ADDENDUM NO. 2

Date of Addendum: January 20, 2016

PROJECT NAME: Gessner Paving and Drainage: Long Point to Neuens Road

PROJECT NO: WBS No. N-000809-0001-4

- Omit Sheet No. 33, Storm Sewer Standards, and replace with Sheet No. 33A, Plan and Profile Long Point Rd East of Gessner Rd.

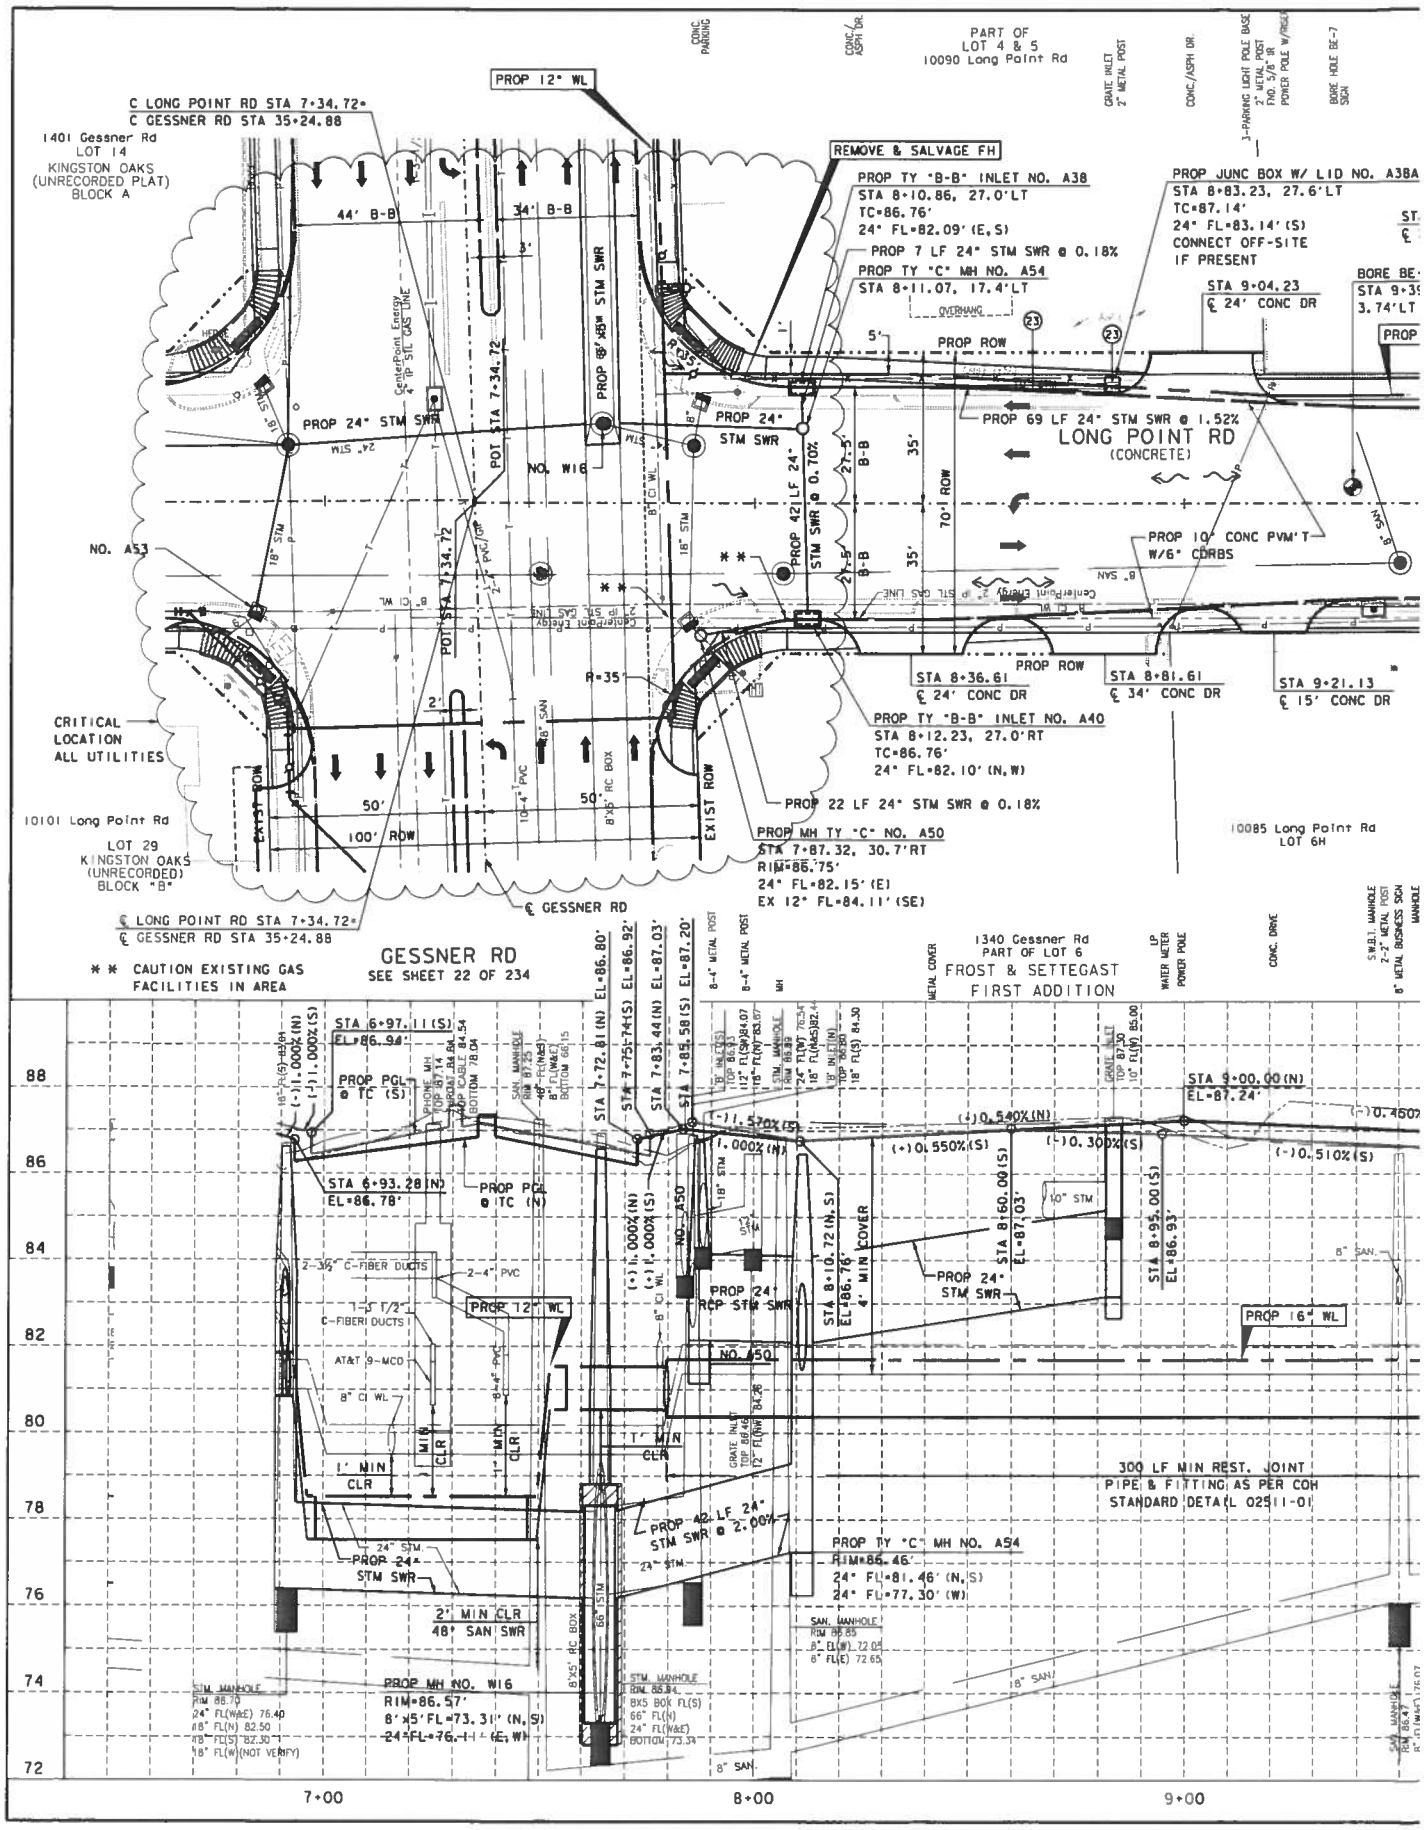
Section 00410B-Bid Form has been modified to include proposed water line improvements along Long Point Rd as shown on plan sheet 33, Plan and Profile Long Point Rd East of Gessner Rd.
